Ref: LBC/19/00686 – TSD06  
Date: 20/08/2025

## **MATERIAL SAMPLES CONDITION: CONDITION 2 APPLICATION – SHIREHALL REF: LBC/2019/00686**

Plate 4: New stone arrived ready for carving

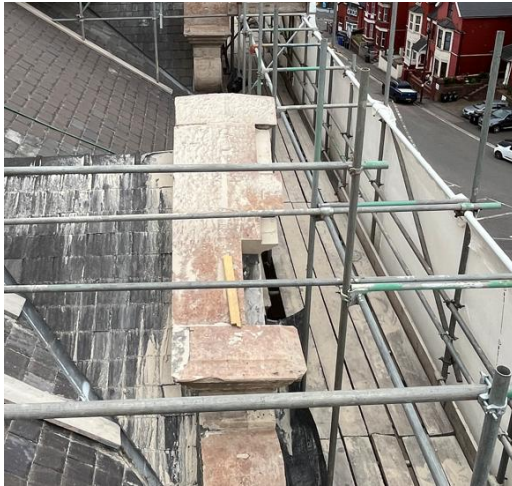
Please find below photographs taken of the samples of materials proposed for the REPLACEMENT of cleaved / cracked STONES of the grins hill / witton fell (buff sandstone colour) on selected areas to South (front) facade at the above applicant site:
